III. Single/Multiple Element Tripping with Protection Violation

S. No.	Event	Event Analysis	Outage Date & time	Points for Review	Remedial Actions Furnished
1	400KV-TIPPAPUR-CHANDALAPUR-2	As per the reports submitted 400 kV Tippapur-Chandalapur line got tripped due to suspected earth leakage in Chandalapur end. The line got tripped at Chandalapur end. DT was sent from Chandalapur end and DT was received at Tippapur end and it tripped. As per the reports submitted 400 kV Chandalapur-Gajwel line tripped at Chandalapur end only due to earth leakage fault. No DR triggered at Gajwel end and line still in the service at Gajwel end.	16-03-2026 12:28	TGTRANSCO: 1. Tripping of the line due to DC earth leakage needs review

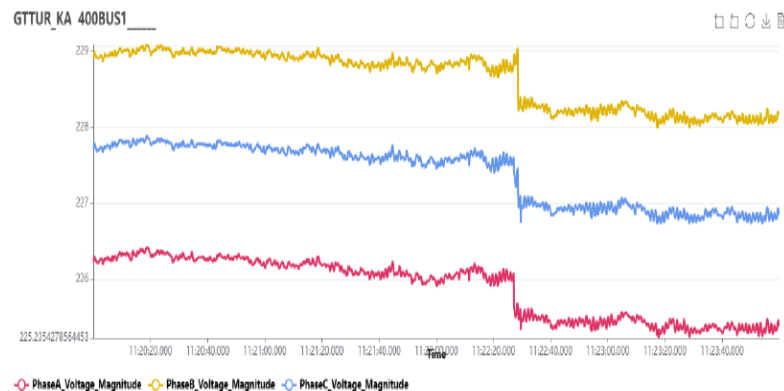
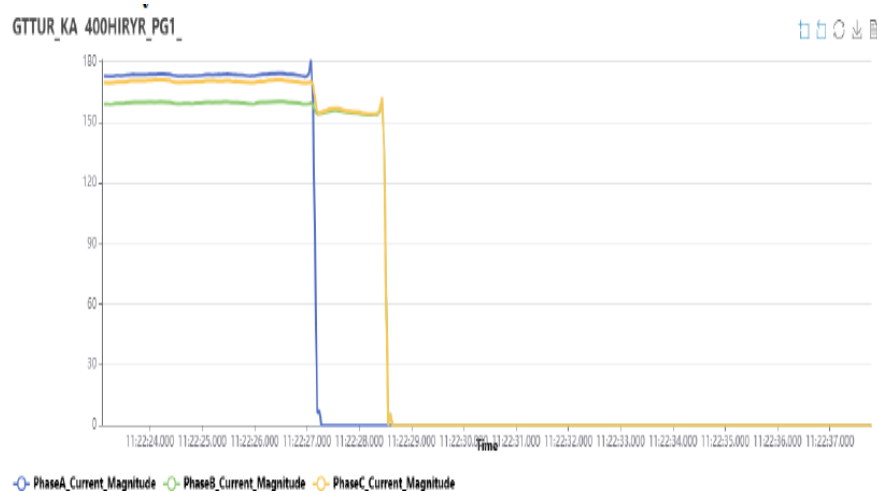
S. No.	Event	Event Analysis	Outage Date & time	Points for Review	Remedial Actions Furnished
11	400KV-GUTTUR-HIRIYUR-1	As per information from KPTCL, the 400 kV-GUTTUR-HIRIYUR-1 line tripped only at GUTTUR end due to the PD relay Aux contact connectivity cable failure leading to the tripping of only R-pole and after around 1.5s suspected PD operated and 3ph tripped (from PMU).	09-04-2026 11:22	KPTCL: 1. Tripping of the 400kV-GUTTUR-HIRIYUR-1 line at GUTTUR only due to PD relay Aux contact connectivity cable failure needs review

➤ From the PMU data, tripping of the line can be observed without any fault and R-pole getting tripped before Y and B phases.

1. KPTCL informed that the 400 kV-GUTTUR-HIRIYUR-1 line tripped at GUTTUR end due to the PD relay Aux contact connectivity cable failure, leading to the tripping of only R-pole and after around 1.5s suspected PD operated and 3ph tripped.
2. KPTCL also informed that at Guttur end line tripped on PD relay due to control cable extending auxiliary contact status to the relay.
3. Damaged control cable was isolated, cable was cleaned and properly insulated before restoring the normalcy. The line was restored at 15.03 Hrs on the same day
4. SRPC mentioned that the cable issues at Guttur station is perennial and advised KPTCL to rectify the same at the earliest. KPTCL informed that PO had been placed for the new cables at Guttur and replacement would be done at the earliest.

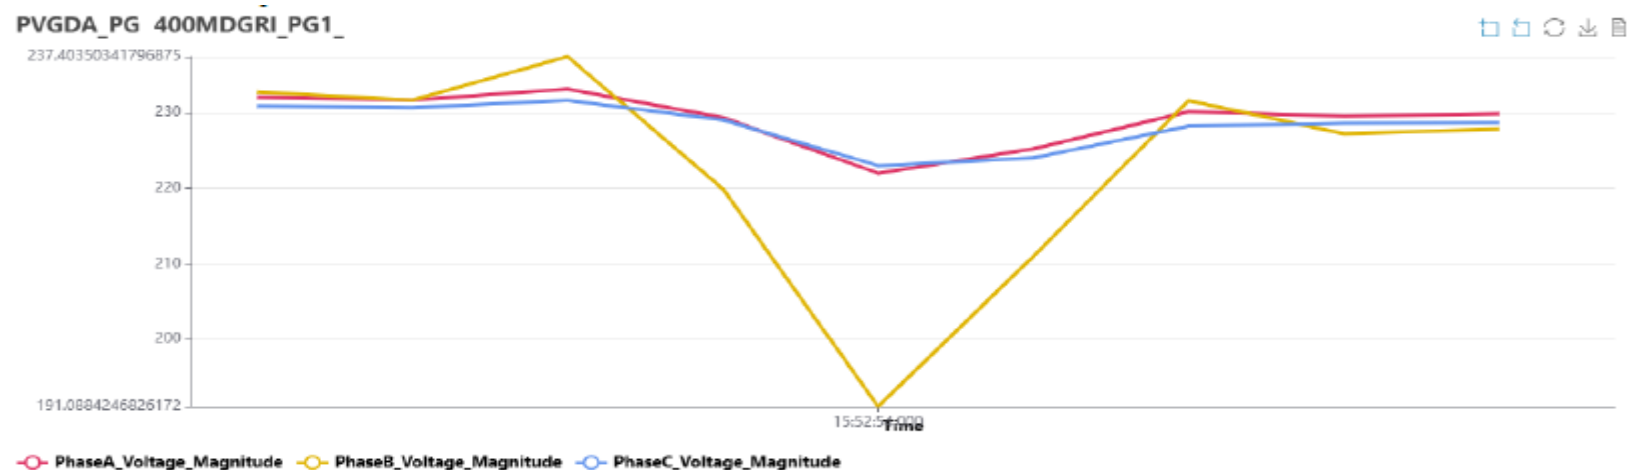
S. No.	Event	Event Analysis	Outage Date & time	Points for Review	Remedial Actions Furnished
12	Multiple trippings at BPS	As per the reports submitted, the triggering incident Y-G fault in BPS-YTPS_1 line. At YTPS end the fault was sensed in Zone 2 and at BPS end the fault was sensed in Zone 1. A/R didn't operate from both the ends. At YTPS end 3 phase tripping was observed and at BPS end upon receiving the DT 3 phase tripping was observed. After tripping of YTPS-BPS-1 line at JSW end of JINDAL-BPS-4 line the fault was sensed in Zone 3 but no master trip was initiated. Line got tripped at Jindal end due to suspected Ground Potential Rise. JINDAL-BPS-4 line was holding from BPS.	13-04-2026 15:52	JSW THERMAL: 1. Tripping of 400 kV-JINDAL-BPS-4 only at JINDAL end during fault in 400KV-BPS-YTPS-1 line needs review

➤ From the PMU plot, Y-G fault can be observed without any delayed clearance.

1. As per the reports submitted, the triggering incident was Y-G fault in BPS-YTPS-1 line. At YTPS end the fault was sensed in Zone 2 and at BPS end the fault was sensed in Zone-1. A/R did not operate from both the ends. At YTPS end 3 phase tripping was observed and at BPS end 3 phase tripping was observed, upon receiving DT.
2. After tripping of YTPS-BPS- line 1 at JSW end it was observed that JINDAL-BPS- line 4 sensed the fault in Zone 3, but no master trip was initiated. Line tripped at Jindal end due to suspected Ground Potential Rise. JINDAL-BPS- line 4 was holding from BPS.
3. KPTCL furnished the tripping details as below:

- 400kV YTPS-BPS line-1 tripped on Y-phase to ground fault.
 - **AT BPS:** YN Fault in Zone-1, Fault location: 0.8km, Iy:24.3kA Carrier send, AR was in progress. After around 450msec DT received from the YTPS end the line was tripped.

- **AT YTPS:** YN fault in Zone-2, Fault current 1.98kA, due to carrier fail, Zone-2 3 phase trip issued after around 450msec (from pick up) and DT signal was sent to Remote end.

- During the above fault, JSWEL-BPS line-4 tripped at JSWEL end suspected due to ground potential raise in their switchyard while the line was holding from BPS end.

4. KPTCL informed that, in the BPS–YTPS- line 1, one carrier channel was under failed condition prior to the incident, and during the incident, failure of the carrier channel card was observed at the YTPS end in the other channel. Consequently, the carrier protection communication failed during the incident.

5. SRPC advised KPCL to rectify the PLCC issues at the YTPS.
 6. KPTCL informed that the Line was restored after thorough inspection of yard at BPS at 16.57 Hrs on the same day.

- ❖ KPCL to rectify the PLCC issues at the YTPS.

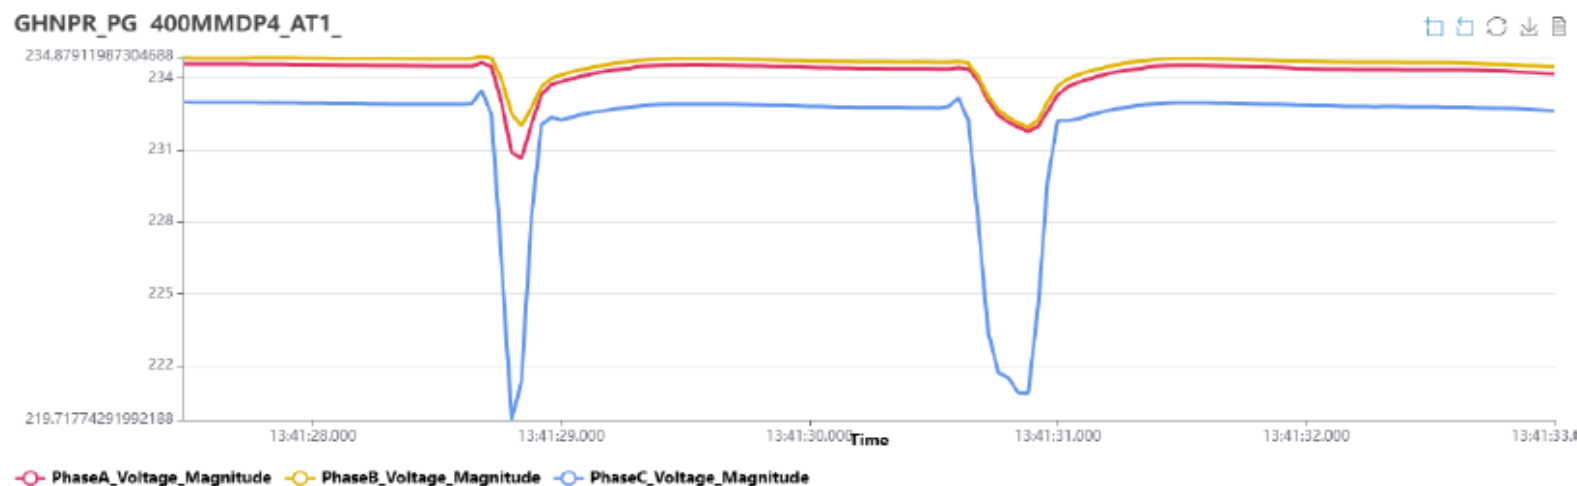
S. No.	Event	Event Analysis	Outage Date & time	Points for Review	Remedial Actions Furnished
13	Multiple trippings at 400kV Chandalapur	The triggering incident is the B-G fault in 400kV GAJWEL-CHANDALAPUR-2 line. At GAJWEL end, the fault was sensed in Z2 carrier aided trip, AR operated and tripped due to persistent fault. At CHANDALAPUR end, the fault was sensed in Z1 and 3ph tripped due to I>4 operation. Also, during the same time 400kV GAJWEL-CHANDALAPUR-1 line tripped only at CHANDALAPUR end due to I>4.	14-04-2026 13:41	TGTRANSCO: 1. Tripping of 400KV-GAJWEL-CHANDALAPUR-1 only at CHANDALAPUR end on I>4 due to fault in 400KV-GAJWEL-CHANDALAPUR-2 line needs review 2. Non operation of AR in 400KV-GAJWEL-CHANDALAPUR-2 at CHANDALAPUR end needs review

1. TGTRANSCO informed that the triggering incident was a B-G fault in 400 kV GAJWEL-CHANDALAPUR-2 line. At GAJWEL end, the fault was sensed in Z2 carrier aided trip, AR operated and tripped due to persistent fault. At CHANDALAPUR end, the fault was sensed in Z1 and 3ph tripped due to I>4 operation. During the same time 400 kV GAJWEL-CHANDALAPUR-1 line tripped only at CHANDALAPUR end due to I>4.

2. TGTRANSCO also informed that AR not operated at Chandalapur end, due to operation of I>3 trip protection in Main-1 Micom P546 relay.
3. For fault on 400kV Chandulapur-Gajwel-2 feeder, 400kV Chandulapur-Gajwel-1 feeder also tripped on I>3 indications in main-I Micom P546 relay at Chandalapur end only. On analysis, it was observed that I>3 (SOTF) was enabled in Micom P546 Main-1 relay.

4. TGTRANSCO also informed that as a remedial action I>3 SOTF function was disabled in Micom P546 Main-1 relay in 400kV Chandulapur-Gajwel-1.
5. SRPC advised TGTRANSCO to review the DR time synchronization at Gajwel SS.

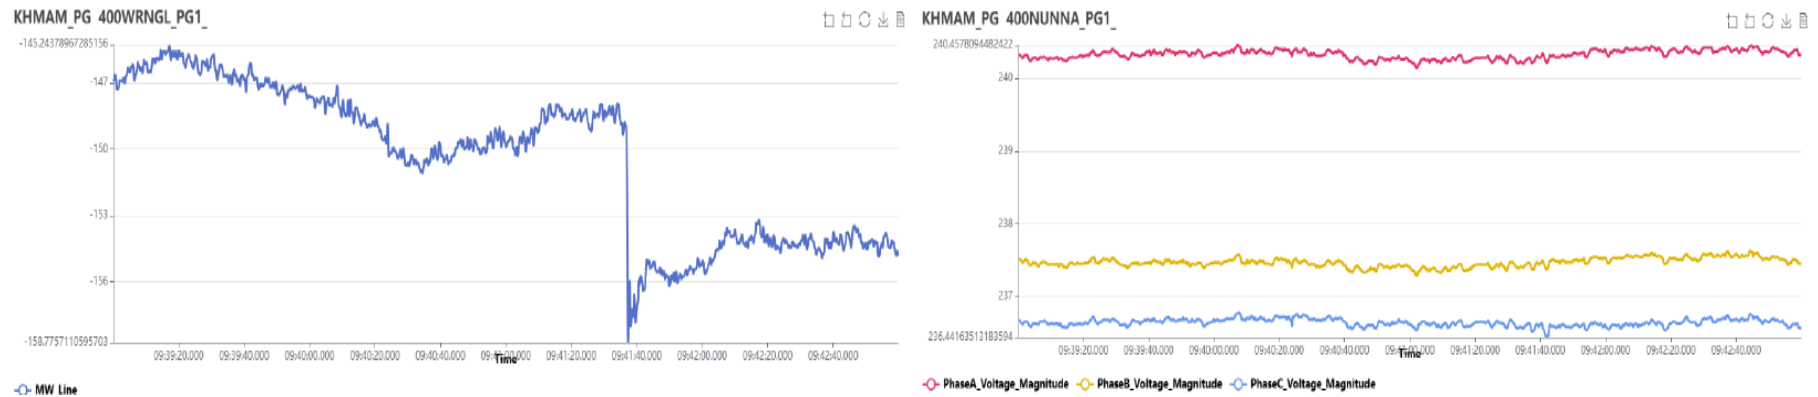
S. No.	Event	Event Analysis	Outage Date & time	Points for Review	Remedial Actions Furnished
14	400KV/6.9KV MANUGURU-ST-1	As per the reports submitted, the triggering incident is the opening of 403-89A R-ph isolator suspectedly due to power fluctuations (i.e. load transfer from Unit to station bus by FBTS), power supply might have been extended to the open contactor (as per FIR). Due to the opening of the isolator led to the imbalance current and earth fault picked and tripped after around 2s.	15-04-2026 09:41	TGGENCO: 1. Opening of isolator needs review 2. Enabling of non-directional EF needs review

➤ From the PMU data there was no fault during the event.

1. TGGENCO informed that in the antecedent condition BTPS Unit-1 (270 MW) was tripped on flame failure protection on 15.04.2026 at 09:41:40 Hrs.
2. Subsequent to this incident, immediately after 2 seconds Station Transformer-1 Tripped on operation of 51N ST HV E/F Protection relay. Upon observation in the field, it was seen that ST-1 Bay 403-89A (bus isolator) was in partially opened condition, i.e., contacts were more than a foot apart and arc was persisting.

3. On further investigation it was observed that there was difference in HV side currents; R Ph- 0A, Y Ph-40.65 A and B Ph-0A & HV neutral current of 40.65 A were recorded in P 643 relay. The earth fault relay setting current was 15A with 2 Seconds time delay. Hence, it was concluded that the protection system operation was intact.

4. TGGENCO further informed that the probable cause of the incident could be attributed to power fluctuations immediately following the unit outage, particularly during load transfer from the Unit to the Station Bus. During this process, power supply might have momentarily extended to the open contactor of isolator 403-89A, resulting in partial opening of the isolator. TGGENCO also stated that the incident may have been caused due to dielectric failure of the isolator open contactor under transient switching conditions.

5. TGGENCO stated that the following remedial actions were taken up on ST-1 isolator 403-89A
 - i. Complete alignment of 403-89A was carried out, open & close limits were set. Manual close/ open and Electrical local/remote open/close operations were carried out.

- ii. Replaced the suspected Open Contactor of Isolator.
 - iii. Both power and control cables measured for IR and found normal.
 - iv. Tested the 51N ST HV E/f Protection relay and found normal.

- v. Contacted the OEM M/s GR Power Engineers and they advised to check the play in J channel assembly, looseness in Gear Box and tandem coupling connections of isolator. As per the OEM advice required maintenance works were carried out on isolator.

- vi. After the above works, closed the isolator and clearance was given for charging of ST.
 - vii. As per OEM advise, kept the isolator on remote and switched off both the AC & DC MCBs, not only for ST-1 but for all 89As of total switchyard also, to avoid repetition of mal operation.
 - viii. The Station Transformer was taken into service on 15.04.2026 at 13:42 Hrs and stage-1 loads transferred on ST-1 at 16:56Hrs and found normal.
6. SRPC enquired about the type of relay used for the earth fault protection. TGGENCO informed that they had implemented non-directional definite time relay with 2 seconds delay for the earth fault protection.
 7. SRPC advised TGGENCO to implement earth fault protection through a Directional Earth Fault (DEF) scheme using an IDMT or Definite time relay, in accordance with the station fault level.

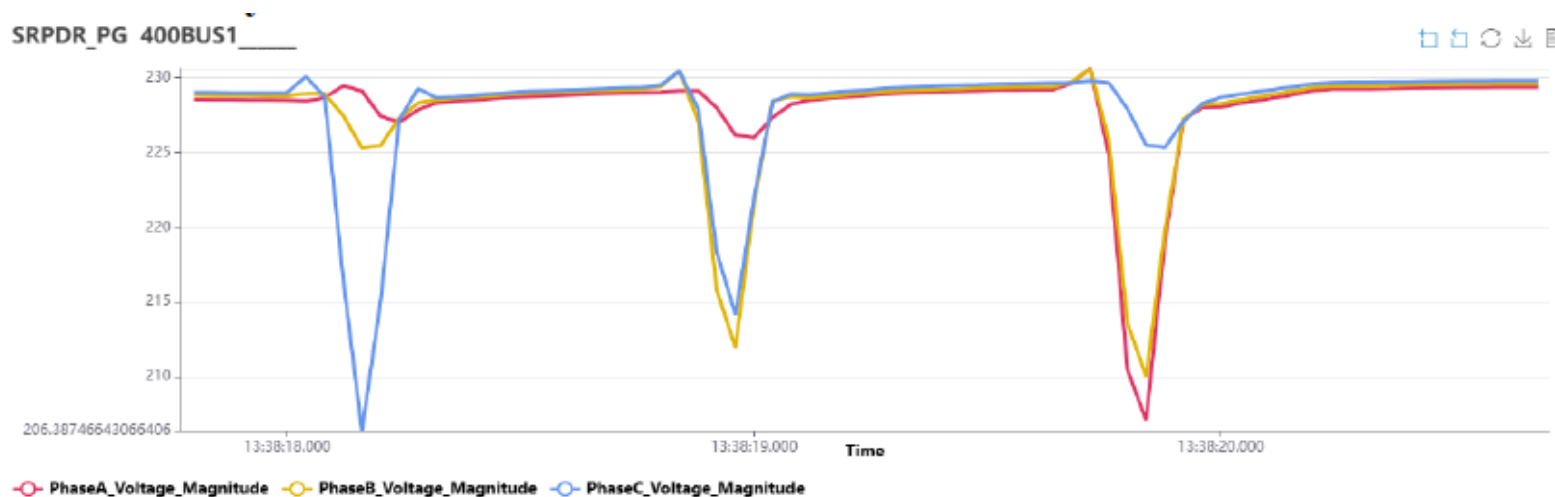
S. No.	Event	Event Analysis	Outage Date & time	Points for Review	Remedial Actions Furnished
15	400KV/230KV SRIPERUMBADUR_TN-ICT-3	As per the reports submitted, the triggering incident was RY fault in external 230kV NCTPS feeder & 230kV Control S feeder. At the same time, 400KV/230KV SRIPERUMBADUR_TN-ICT-3 tripped on maloperation of Buchholz relay due to oil turbulence.	15-04-2026 13:38	TANTRANSCO: Tripping of 400KV/230KV SRIPERUMBADUR_TN-ICT-3 for external fault

From the PMU plot R-Y fault can be observed.

1. The triggering incident was RY fault in external 230 kV NCTPS feeder & 230 kV Control S feeder. At the same time, 400 kV / 230 kV SRIPERUMBADUR_TN-ICT-3 tripped on maloperation of Buchholz relay due to oil turbulence.
2. TANTRANSCO informed that on analysing the DR, no internal fault was observed. Buchholz trip may have been initiated due to oil turbulence during external fault.
3. TANTRANSCO also informed that after the incident DGA test was conducted on Transformer & found normal. After line patrol, ICT was normalized.
4. SRPC advised TANTRANSCO to review the DR time synchronization at 230 kV SRIPERUMBADUR.

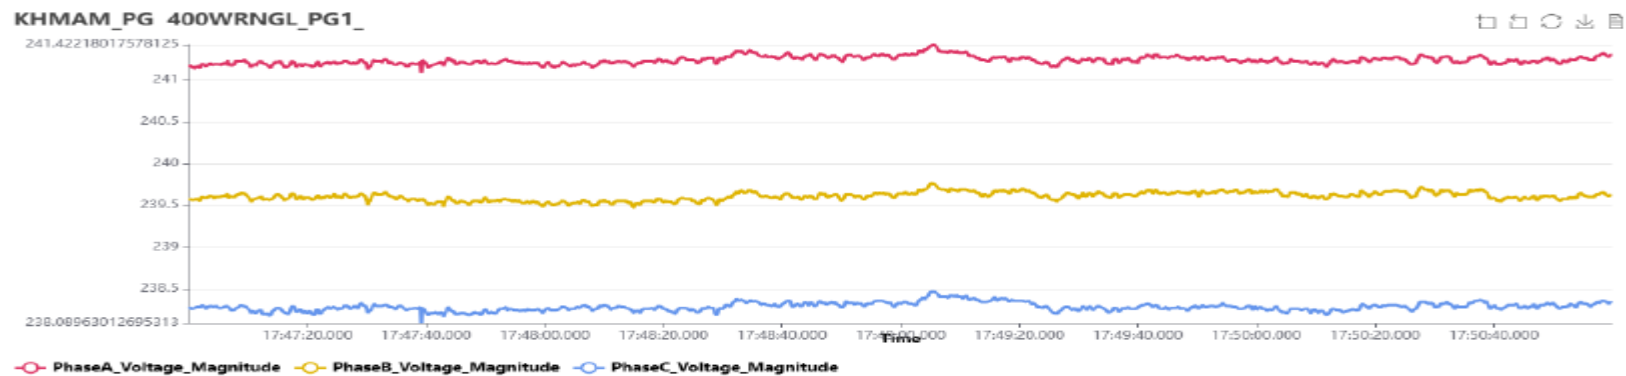
S. No.	Event	Event Analysis	Outage Date & time	Points for Review	Remedial Actions Furnished
16	400KV-HINDUJA-KALPAKKA-2	As per the reports submitted, line got tripped due to human error at Kalpakka end during the charging of Bus Reactors and no protection operation is seen in the DR. At Hinduja end DT was received and the line tripped.	16-04-2026 17:49	<u>APTRANSCO</u> : 1. The reason for tripping of line at Kalpakka end needs review

➤ From the PMU data no fault was observed.

1. APTRANSCO informed that on 16/04/2026 at 17:49 Hrs closing codes were issued to 63 MVAR Bus reactor-3 and 125 MVAR Bus reactor-4. While charging of Bus reactor, Shift operator selected a wrong window (i.e., 400kV Kalapaka-HNPCL-1). Hence, trip command extended to CB of HNPCL-2 (402) feeder and Direct trip sent to remote end.
2. APTRANSCO informed that, strict instructions were issued to shift Engineers to avoid human errors and line trippings.
3. SRPC advised APTRANSCO to follow the SOP during the transmission element charging.

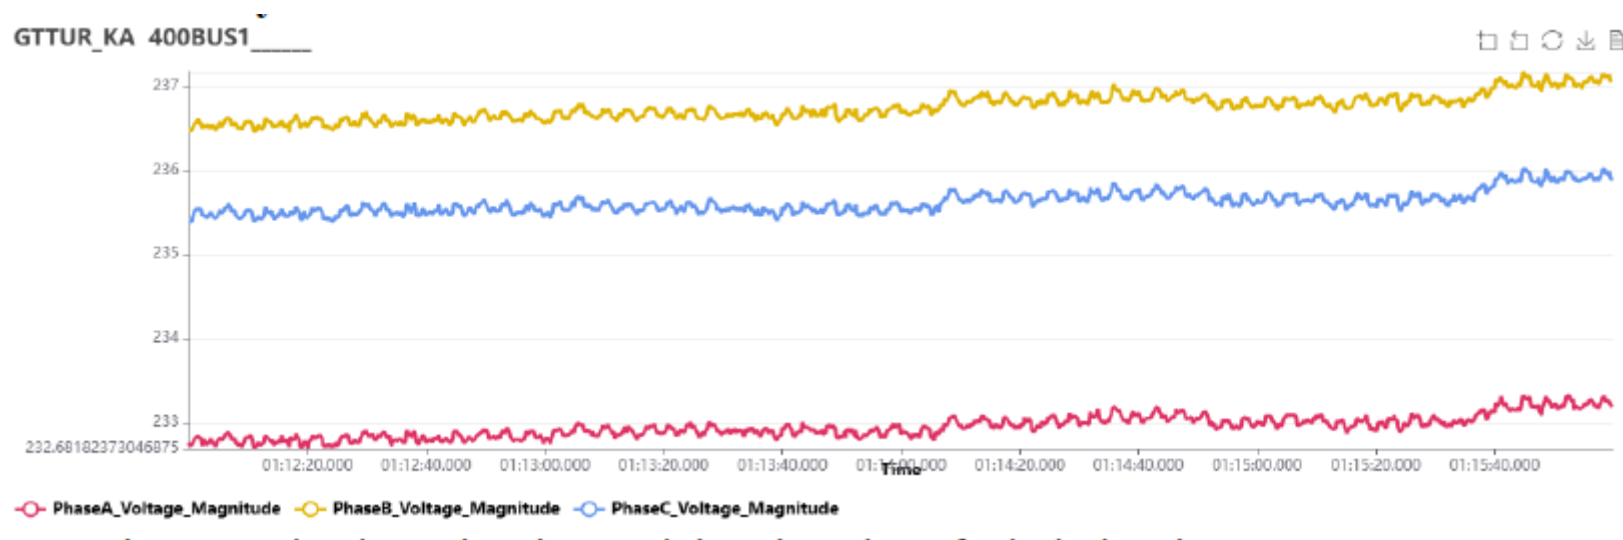
S. No.	Event	Event Analysis	Outage Date & time	Points for Review	Remedial Actions Furnished
17	400KV/220KV GUTTUR-ICT-1	As per reports submitted, the triggering incident was closing of TCIV of 400 kV/220 kV ICT-1. Due to closing of TCIV no oil circulated from conservator to main tank leading to Buchholz tripping of the transformer.	19-04-2026 01:16	<u>KPTCL</u> : Bucholz relay maloperation needs review	<u>KPTCL</u> : TCIV valve was reset & kept to back into service mode and observed no oil flow through the valve. Hence valve was kept in filtration mode to enable oil circulation. Air was released from all vents of the power transformer & Bucholz relay was reset. In this incident it was found that the Aircel bag of conservator was damaged and oil oozed out through breather. The breather set with silica gel was replaced by new one.

➤ From the PMU plot, it can be observed that there was no fault during the event

1. As per reports submitted, the triggering incident was closing of TCIV (Transformer Conservation and Isolation Valve) of 400/220 kV ICT-1. Due to closing of TCIV no oil circulated from conservator to main tank leading to Buchholz tripping of the transformer.

2. KPTCL informed that at 01.14 Hrs on 19.04.2026 at Guttur, 315 ICT-1 tripped on Buchholz relay operation. On inspection TCIV CTR valve was found closed (suspected mal-operation) affecting oil circulation from conservator to main tank leading to Buchholz trip.

4. In this incident it was found that the Aircel bag of conservator was damaged. Action had been taken for replacement of damaged Aircel and TCIV valve, material supply awaited.

3. KPTCL also informed that as Remedial measures TCIV valve was reset & kept back into service mode and observed no oil flow through the valve. Hence, valve was kept in filtration mode to enable oil circulation.

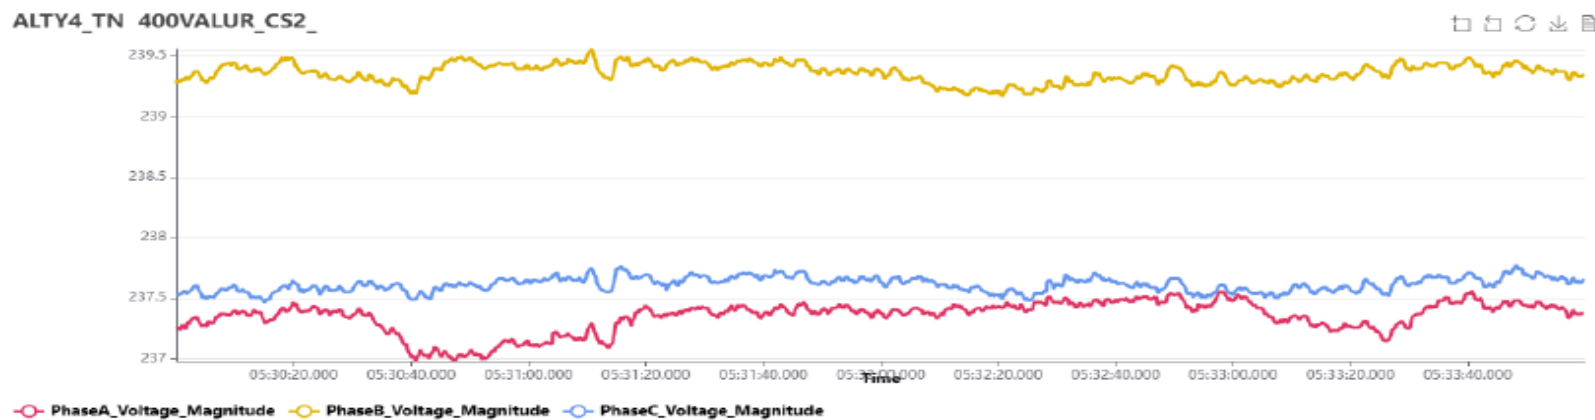
S. No.	Event	Event Analysis	Outage Date & time	Points for Review	Remedial Actions Furnished
18	400KV/230KV PULIYANTHOPE-ICT-1	As per the reports submitted, the ICT tripped due to OLTC PRV maloperation due to sluggish contacts of the PRV.	19-04-2026 05:32	TANTRANSCO: Reason for PRV maloperation	TANTRANSCO: Both NO contacts of OLTC PRV were made series for Tripping to avoid spurious tripping

- From the PMU data, the fault was not observed.

1. As per the reports submitted, the ICT tripped due to OLTC PRV maloperation due to sluggish contacts of the PRV.
2. TANTRANSCO informed that both NO contacts of OLTC PRV was made series to avoid spurious tripping.
